Access Compliance Report Public Rights-of-Way (Curb Ramps)

Intersection ID: 44955 Main Street: OAKTON_HUNT_DR Cross Street: WEAVERS_GLENN_PL Location: SW

ADA ID: E18D8BDE708F Ramp Type: PerpDiag Initial Pass/Fail: Fail Overall Compliance: No Severity Score: 8.75

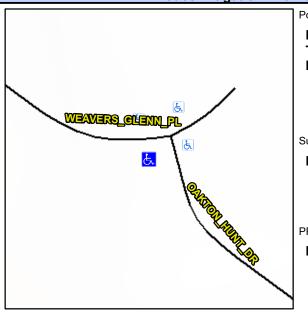
Not Found, R304.5.1

i ieiu ivieasui e	mema/c	onipo	nent compnance		
Compliance Description		Data	Compliance Description		Data	
N/A	Ramp Length (in)	50.0	Yes	Ramp Slope (%)	5.0	
No	Ramp Width (in)	45.0	Yes	Ramp XSlope (%)	0.8	
N/A	Flare Type LT	N/A	N/A	Flare Type RT	N/A	
N/A	Flare Slope LT (%)	N/A	N/A	Flare Slope RT (%)	N/A	
N/A	Flare Traversable LT?	N/A	N/A	Flare Traversable RT?	N/A	
N/A	Landing Length (in)	N/A	N/A	DWS Provided?	N/A	
N/A	Landing Width (in)	N/A	N/A	DWS Contrast?	N/A	
N/A	Landing Slope (%)	N/A	N/A	DWS Length (in)	N/A	
N/A	Landing X Slope (%)	N/A	N/A	DWS Full Width?	N/A	
N/A	Landing Curb? (Y/N)	N/A	N/A	DWS Offset (in)	N/A	
N/A	Shared Landing?	N/A				
N/A	Gutter Ponding?	N/A	N/A	Gutter Slope (%)	N/A	
N/A	Gutter Lip Ht (in)	N/A	N/A	Gutter X Slope (%)	N/A	
N/A	Painted X Walk1?	No	N/A	Painted X Walk2?	No	
	X Walk 1 Direction	To E		X Walk 2 Direction	To N	
N/A	X Walk 1 Width (in)	N/A	N/A	X Walk 2 Width (in)	N/A	
	X Walk 1 Slope (%)	6.5		X Walk 2 Slope (%)	4.0

Remove & Replace Curb Ramp With Two New Directional Ramps or Equivalent.
